**STAFF REPORT: MAY 14, 2025 MEETING**  
**APPLICATION NUMBER: HDC2025-00164**  
**ADDRESS: 1535 BROADWAY**

**SCOPE: PAINT MURAL ON BUILDING**

*Option One: 25'W x 30'L = 750 square feet*

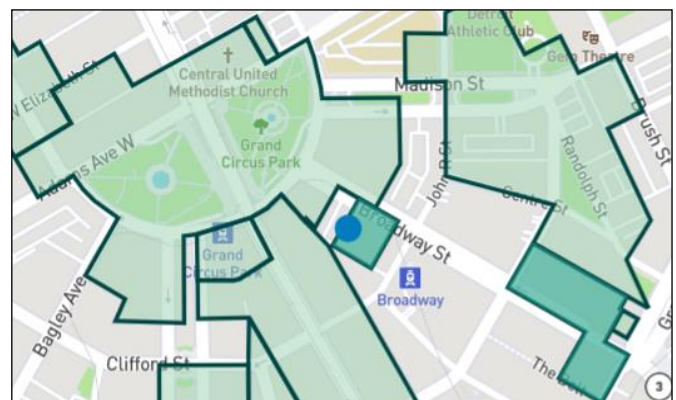
- The ghost signs are important features of the district and should remain intact when possible. Staff recommends the Commission select the 25'W x 30'L mural size and location for the following reasons:

- The mural will not cover nor alter any distinctive character-defining features of the building.
  - The mural won't remove, cover, nor alter the existing ghost signs.

- The 25' x 30' mural is more proportional to the existing signs and the two-story masonry wall.
  - The mural will also leave most of the brick wall unpainted, allowing the wall to retain its permeability to shed water.

- The ghost signs shall remain in place. The Commission selected the 25'W x 30'L mural size and location for the following reasons:
  - The mural will not cover nor alter any distinctive character-defining features of the building.

- The mural won't remove, cover, nor alter the existing ghost signs.
  - The 25' x 30' mural is more proportional to the existing signs and the two-story masonry wall.
